City of Poulsbo

Subject: Old City Hall Apartments; Request for Revisions, P-07-12-17-01

To: Nikole Coleman, Associate Planner
From: Anthony Burgess, Sr. Engineering Technician
Subject: Old City Hall; Request for Revisions; *October 31, 2018 Submittal*
Date: November 30, 2018

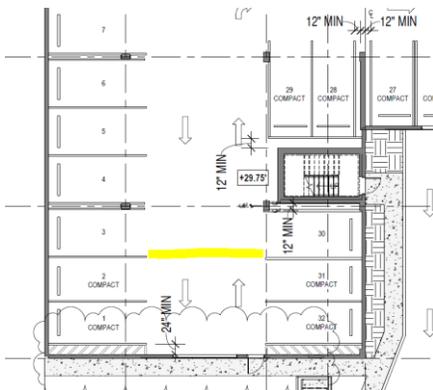
3. Per [PMC 18.140.040 A](#), the minimum aisle width for 2-way traffic with 90 degree parking is 24 feet. This standard is not being met in the highlighted area shown below. Please revise.

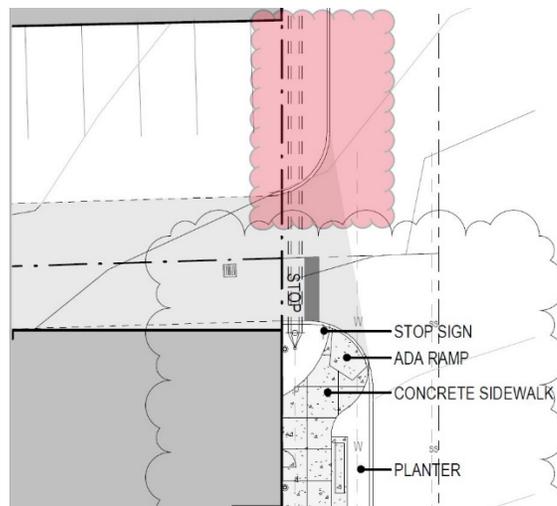
8. Response Letter Item #1 proposed new sidewalk orientation at the northern access road and advance signage for the stop sign at Jensen Way. The proposed advance signage, Stop Sign location, and sidewalk layout is acceptable. However, the new sidewalk orientation in front of the new building does not correctly tie into existing sidewalk both north and south of the proposed project. Additional offsite sidewalk improvements will be required to provide correct traffic flow fixtures within the roadway. I have attached a snapshot of what I am speaking to clouded red, specifically the northern sidewalk will need to be expanded to match what you are proposing. This area is already striped as no parking. Please submit with the next submittal how you plan to address this.
